## Request for Information

**Project:** RFPD Fire Station #3  
RFI Number: 29  
Date: 9/1/2009

RFI #29

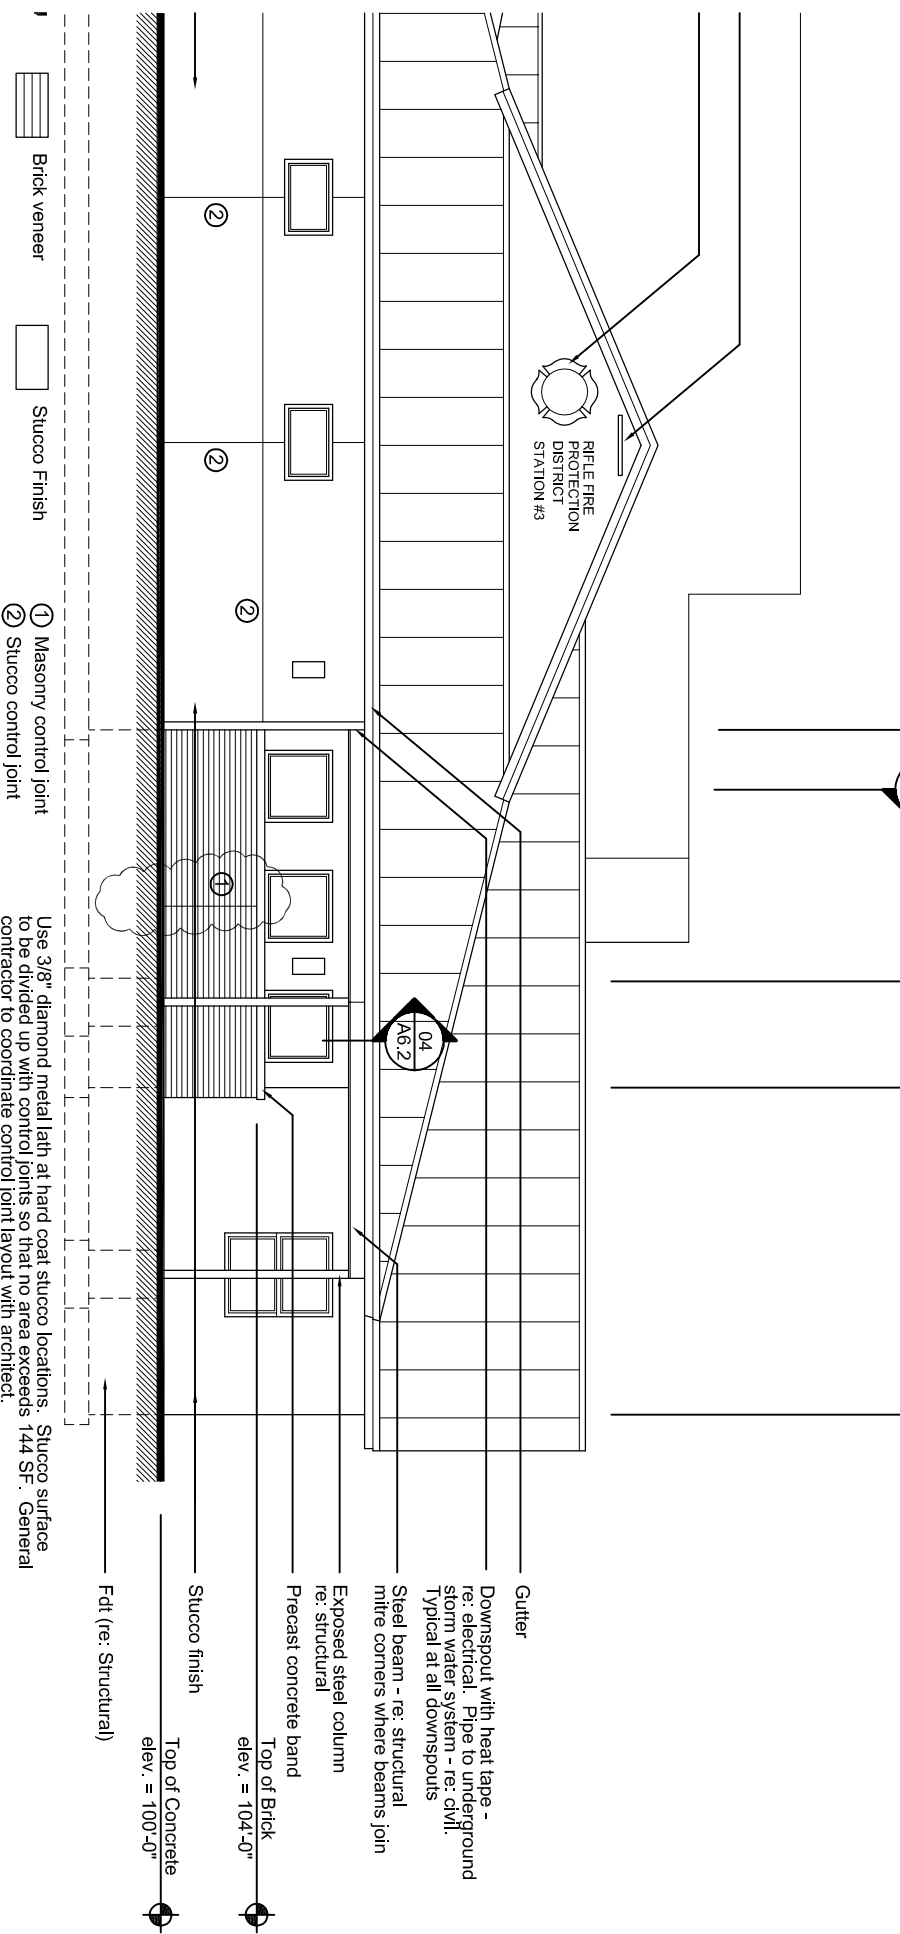
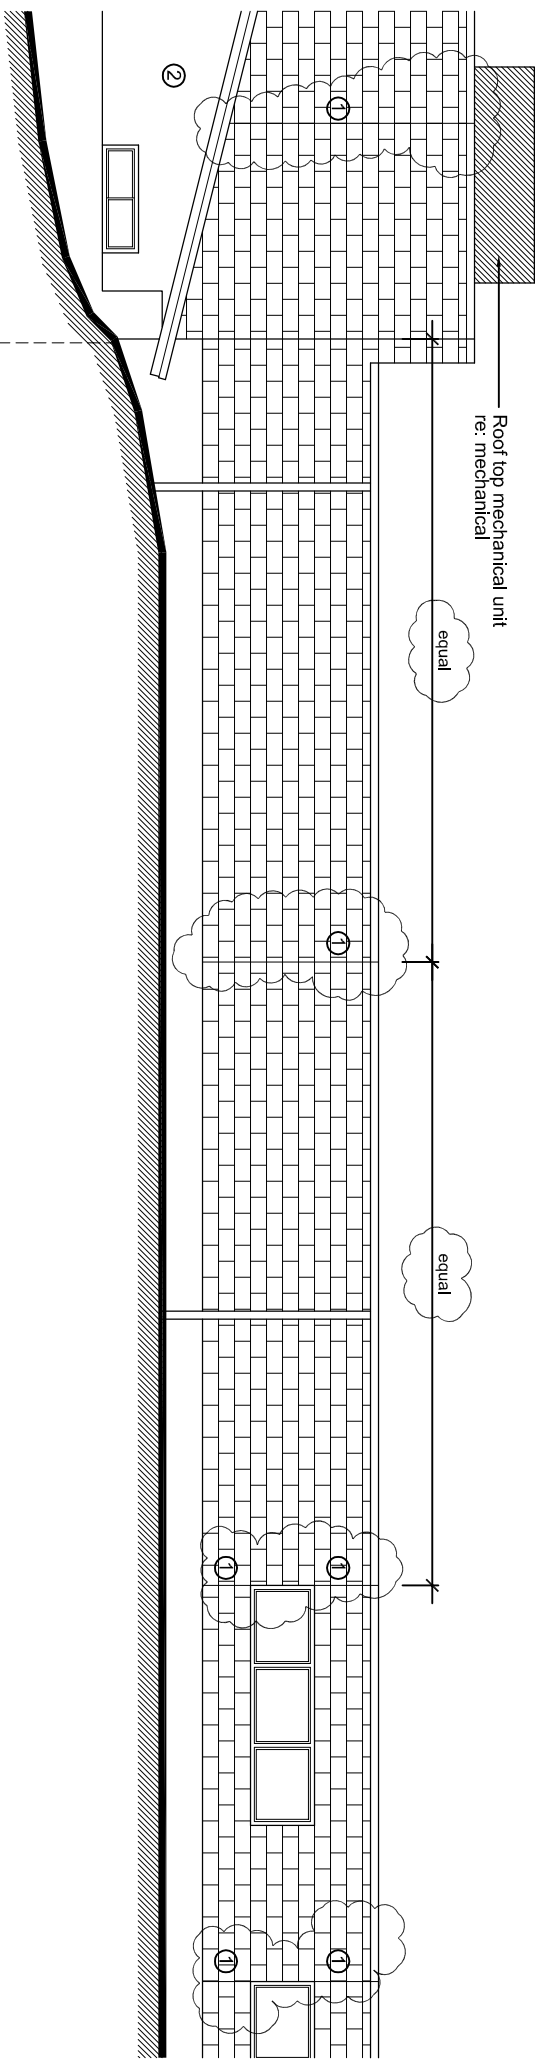
May we get a layout of masonry control joints, or can we put them where we would like as long as we never have more than 35' of wall without a control joint?

*Refer to attached elevations for missing control joint locations. Control joints at the north side of the Apparatus Bay to match those indicated on the south elevation. Control joints at the entry tower south side to match those indicated on the entry tower north side. Control joints at the entry tower west side to match those indicated on the entry tower east side.*

All east wall exterior brick, block and stucco details to continue around exterior side and through north side of Apparatus Bay wall (grid 3).
